Re: **Approval with Modification,
Partial Disapproval and Conditions of Approval of
the May 15, 2002, Revision 2, Site Investigation Work Plan
J.H. Baxter & Co., Arlington, Washington Facility
Administrative Order on Consent (Order)
Docket No.: RCRA-10-2001-0086
EPA ID No.: WAD 05382 3019**

Re: **Approval with Modification,
Partial Disapproval and Conditions of Approval of
the May 15, 2002, Revision 2, Site Investigation Work Plan
J.H. Baxter & Co., Arlington, Washington Facility
Administrative Order on Consent (Order)
Docket No.: RCRA-10-2001-0086
EPA ID No.: WAD 05382 3019**

EPA MODIFICATIONS TO May 15, 2002, Site Investigation Work Plan, J.H. Baxter & Co., Arlington, Washington Facility, Revision 2

on Specific Portions of the May 15, 2002, Site Investigation Work Plan, J.H. Baxter & Co., Arlington, Washington Facility, Revision 2

Figure 3-1
**HUMAN HEALTH
CONCEPTUAL SITE MODEL**

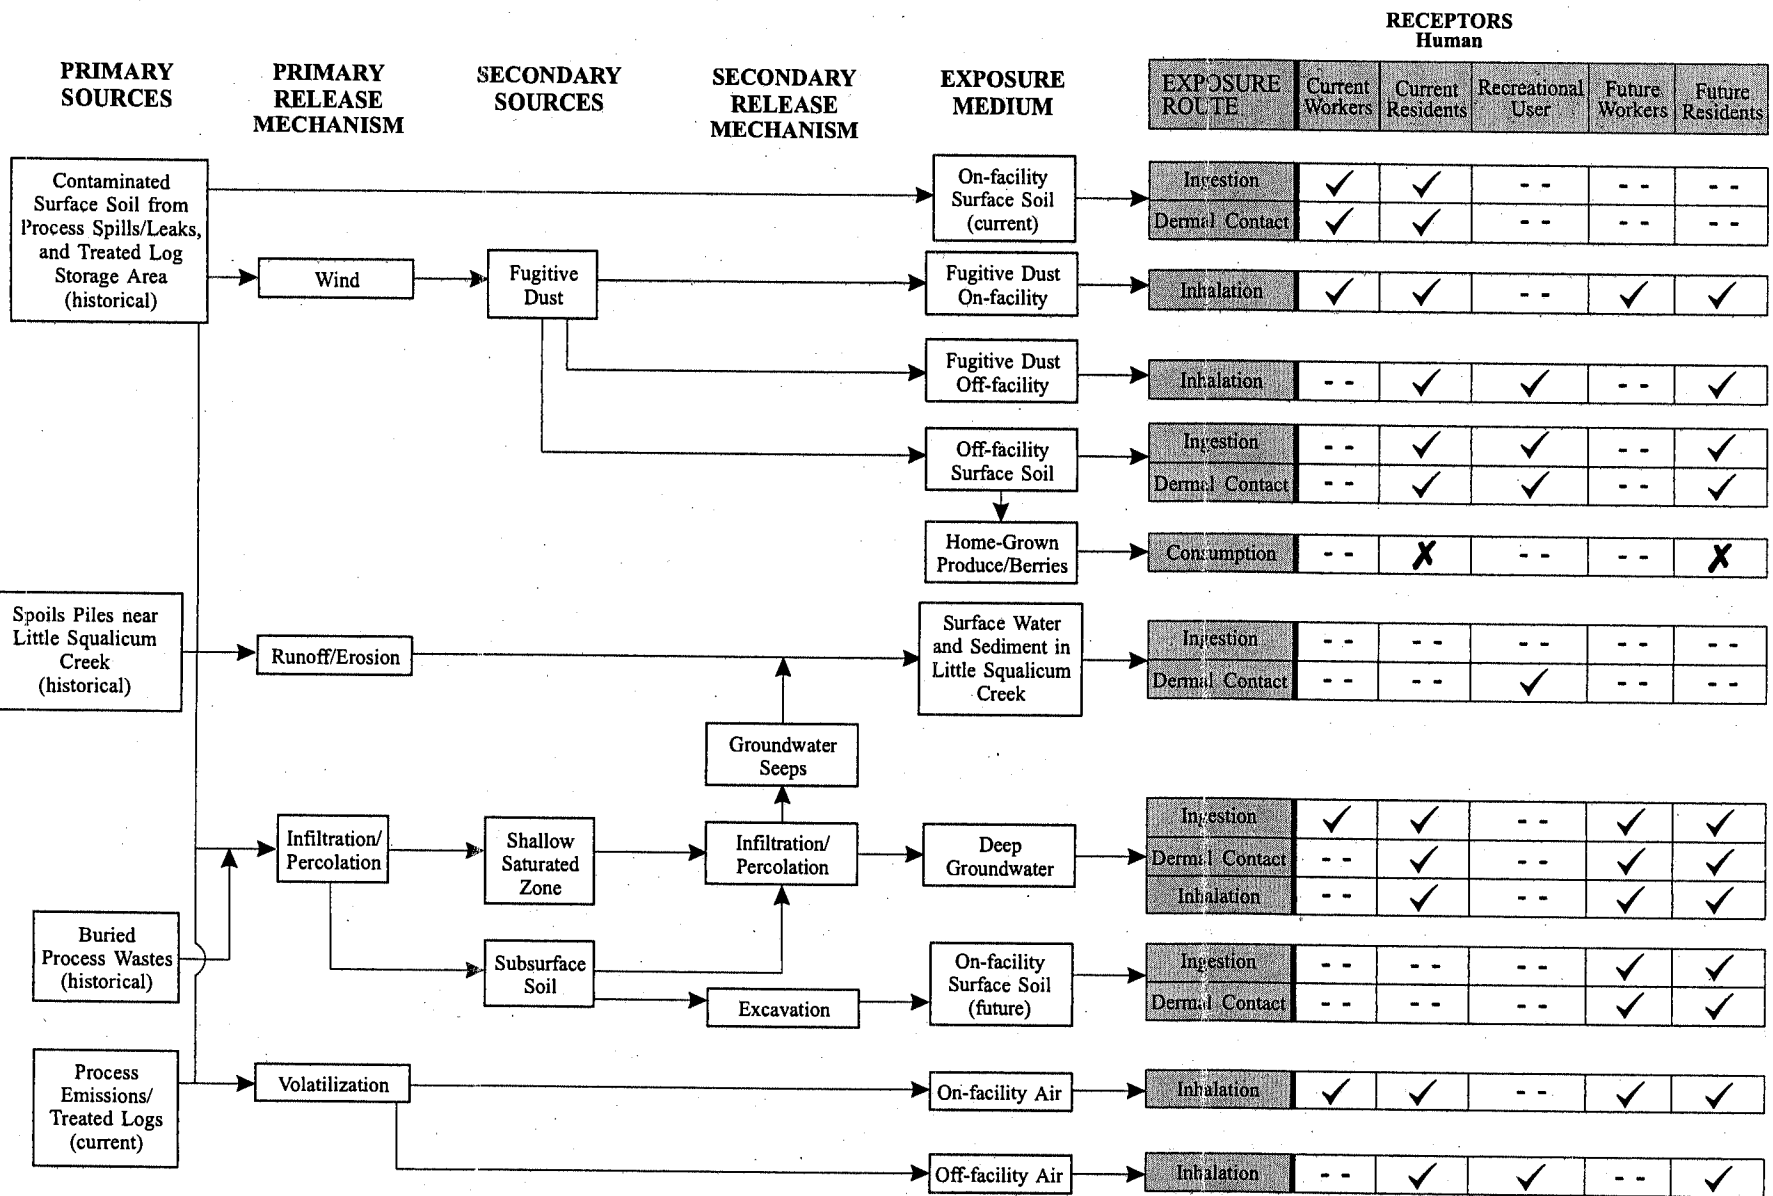
6. Section 6: Provide a risk assessment-specific conceptual site model (CSM) that depicts potential migration pathways, exposure routes, potentially exposed receptors, and exposure pathways. Typically on the right hand side of this model, a list of receptors is provided with all the possible exposures they may experience (e.g., ingestion of soil,

inhalation of dust). This type of CSM is used to ensure that data needed to support a risk assessment is obtained. An example is attached to this enclosure
